LETTER SUBMITTING PROPOSED REVISIONS TO THE SHORELINE PROTECTION
SYSTEM NAS KEY WEST
2/4/1997
BECHTEL ENVIRONMENTAL

SUBJECT: Bechtel Job No. 22567
Department of the Navy Contract No. N62467-93-D-0936
DO 0004: SHORELINE PROTECTION SYSTEM, FLEMING KEY, NAS KEY WEST, FL;
FDEP PERMIT NO. 442959285; U. S. ARMY COE PERMIT NO. 199604865 (IP-EJ)
Subject Code: 5090

DRAWING TITLE
TYPICAL ARMORFLEX CROSS SECTION

TYPICAL ARMORFLEX CROSS SECTION

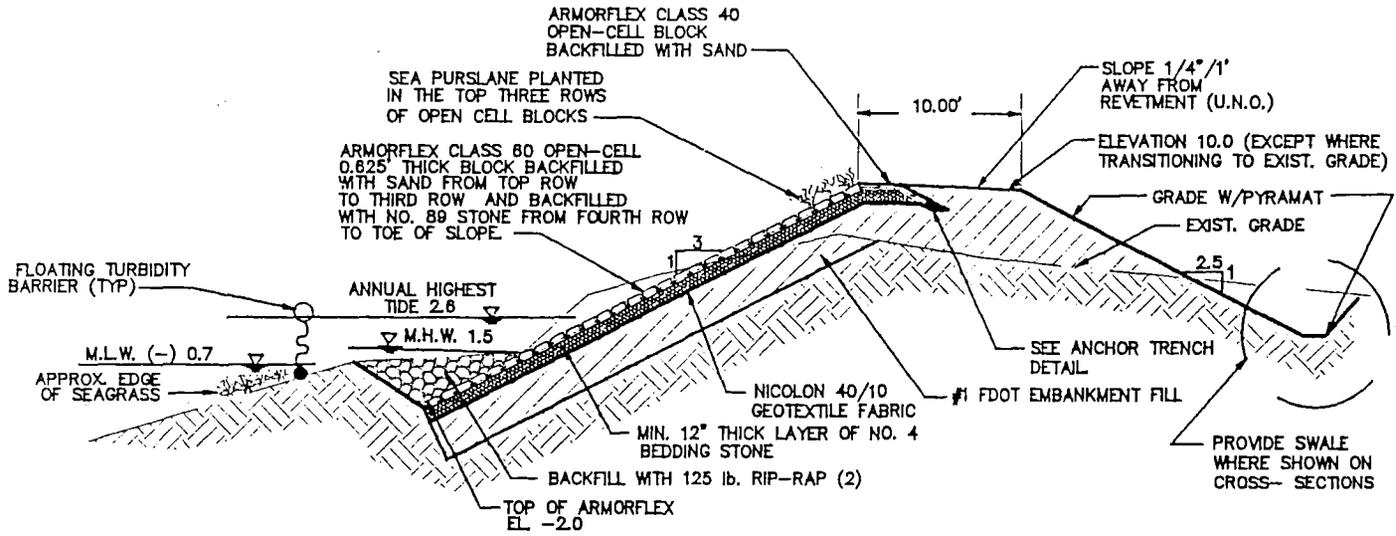
Enclosed is a proposed revision to Monroe County - ERP File No. 442959285 wetlands permit. The revision is to the "Typical Armorflex Cross Section" that was included in the permit application as Attachment 6a. The front slope of the berm has been changed from a combination of 2h:1v and 2.5h:1v to a continuous slope of 3h:1v. This is necessary because, it was determined that the factor of safety of the steeper slope was not adequate under critical design wave loadings.

Several options were investigated to raise the factor of safety to an acceptable level. Reduction of slope angle was selected as the best option because it measurably improves overall stability of the system, whereas other alternatives were inconclusive, at best. We believe the slope change does not affect wetlands.

The construction will start at the same point on the waterward side of the berm; therefore, the area of wetlands impacted is not changed by virtue of this revision; nor will there be any impact to seagrass. The floating turbidity barrier will be installed as shown in the permit application. Construction above the water line will cover a wider area than previously shown, and we will remove more exotic species; i.e., Australian Pines, than previously indicated. The planting of sea purslane and red mangroves remains the same.

The change in slope does affect the cross sections included in Attachment 8 of the permit application. The primary change to these drawings is that the top of the berm and the back slope shift about ten feet inland. Since changes to these cross sections are minor, a revised Attachment 8 is not included with this letter.
